**Accessibility Advisory**

**Committee – April 28, 2025**

# Vaughan Inclusive Design Standards

Proposed Updates  
April 2025

# Temporary Conditions

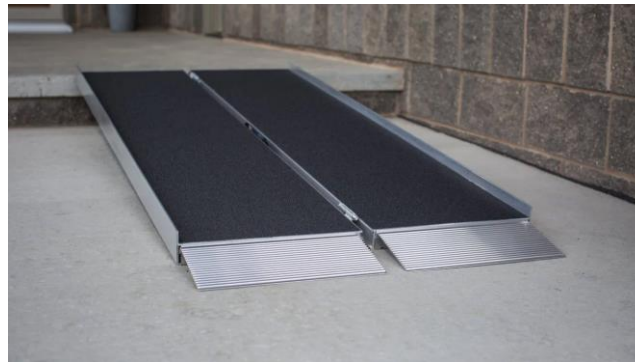
Expand the Scope of the IDS to Include Temporary Conditions

Add New IDS Section 6.22, "Temporary Conditions":

Applies to areas and building elements which are in the process of maintenance, renovation or alteration and to moveable elements which are not intended to be permanent.

# Bilingual and Braille Signage

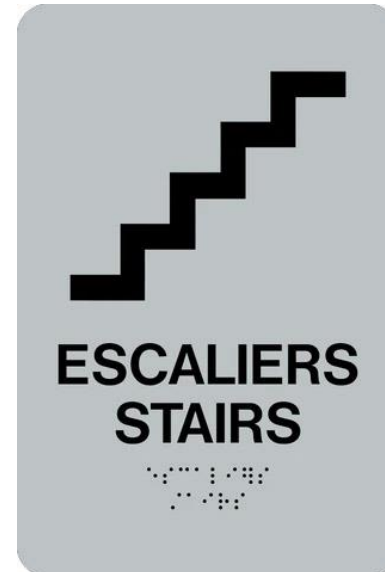
Add Requirements for French and Braille Signage to the IDS

Modify IDS 5.8 to Require Bilingual Visual and Braille Signage

Where text is present, include bilingual text in English and French;

Where English braille is provided, provide French braille as well;

Require standardized braille: Unified English Braille (UEB) and Code Braille Français Uniformisé (CBFU)

# Connections

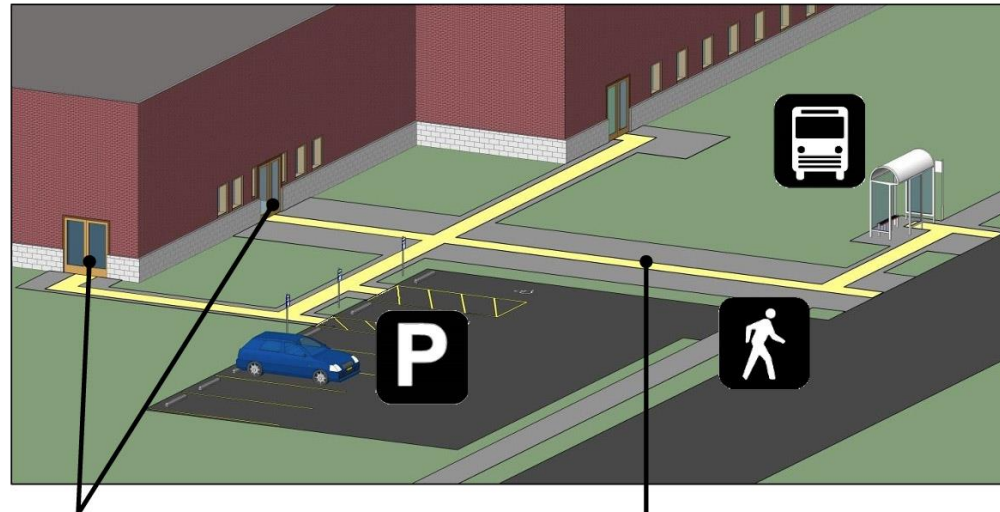
Specify that an Accessible Route Shall Connect all Accessible Areas

Modify IDS Section 3.3 (Exterior) and 4.3 (Interior):

"Exterior paths of travel complying with this section shall connect the main building entrance to all accessible areas and amenities on site and to a pedestrian walk within the public way."

"Interior accessible routes complying with this section shall connect building entrances to all accessible areas within a building."

# Eating Areas

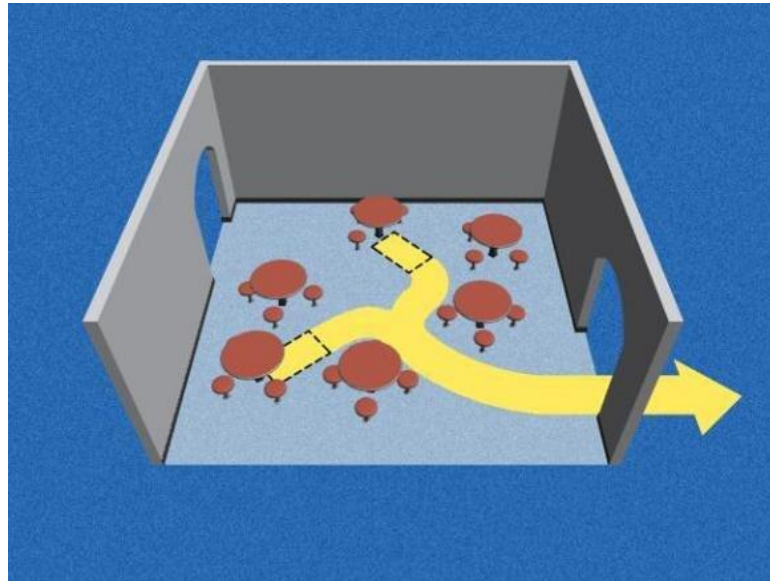
All Public Use Eating Areas Shall Be Accessible

## Modify IDS Section 6.4.4 Cafeteria and Dining Facilities

# Larger Parking Stalls

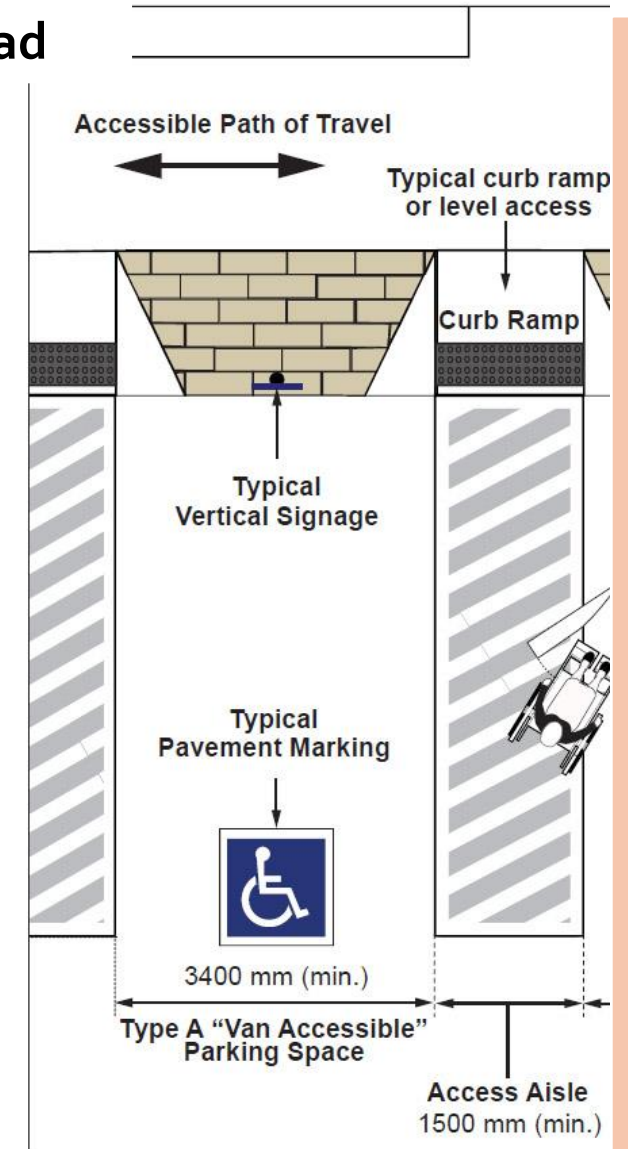
## All Accessible Spaces to have 3000mm overhead

We do not support this recommendation because it doesn't improve accessibility

- The U.S. requires 2500 mm (Vans are not larger in Canada).
- Vaughan IDS already requires 2750mm.
- Most indoor parking floors could not comply

## All Accessible spaces to be Van Accessible

We do not support this recommendation because the need is not demonstrable

- Adds 1m width - reduces total parking count
- Need not supported by available data

# Larger Parking Stalls

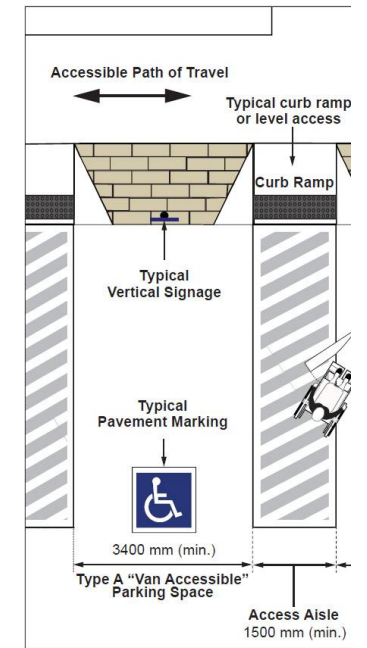
## All Electric Vehicle spaces to be Van Accessible

We do not support this recommendation because:

- It would add 2.9m to the width of EV spaces;
- The vast majority of EV users would not benefit from additional width;
- Becomes increasingly infeasible as the demand for EV charging spaces grows;
- It would punish developers for providing EV spaces.

Require EV Charging at Van Accessible spaces in parking facilities which have EV spaces.

# Egressability

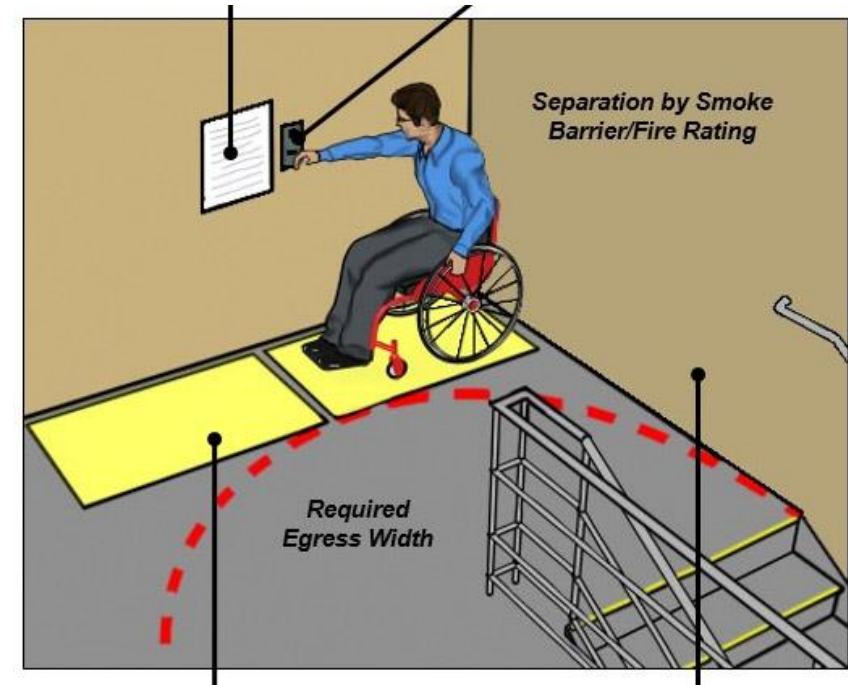
Make all Ground Floor Exits Accessible, etc.

We do not support these recommendations because it concerns life safety.

Life Safety should be handled by the Building Code
